# Product / Process Change Notification

N° 2018-013-A

## Capacity Extension by Introduction of 300mm Wafer Diameter for Dedicated OptiMOS™ Products at Infineon Technologies Dresden, Germany & Harmonization of Bill of Material (BoM)

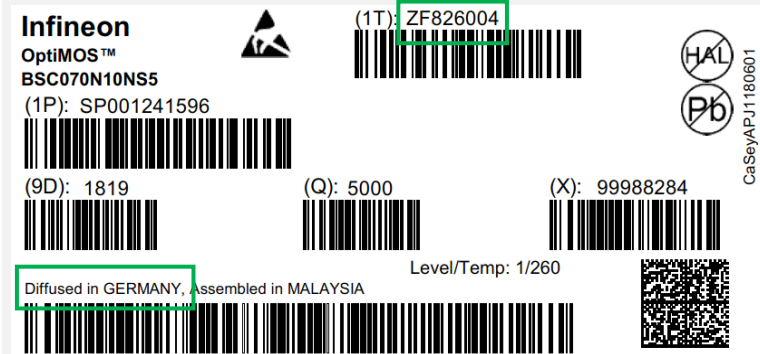
<u>Old</u>	<u>New</u>
(a) Wafer production sites with wafer diameter:	<ul style="list-style-type: none"> <li>■ Infineon Technologies Austria AG, Villach, Austria (200mm)</li> </ul>	<ul style="list-style-type: none"> <li>■ Infineon Technologies Austria AG, Villach, Austria (200mm)</li> <li style="text-align: center;"><i>and</i></li> <li>■ Infineon Technologies Dresden GmbH, Germany (300mm)</li> </ul>

(b) Standardization of pad design and metallization process:	<ul style="list-style-type: none"> <li>■ Al/Cu</li> <li style="text-align: center;"><i>and</i></li> <li>■ Cu</li> </ul>	<ul style="list-style-type: none"> <li>■ Cu</li> </ul>

(c) Standardizing mould compound TDSON-8 package:	<ul style="list-style-type: none"> <li>■ Hitachi CEL 1772</li> </ul>	<ul style="list-style-type: none"> <li>■ Hitachi CEL 9240</li> </ul>

(d) Standardizing of gate wire bond TDSON-8 package:	<ul style="list-style-type: none"> <li>■ 38µm Au</li> <li style="text-align: center;"><i>and</i></li> <li>■ 30µm Au</li> </ul>	<ul style="list-style-type: none"> <li>■ 30µm Au</li> </ul>
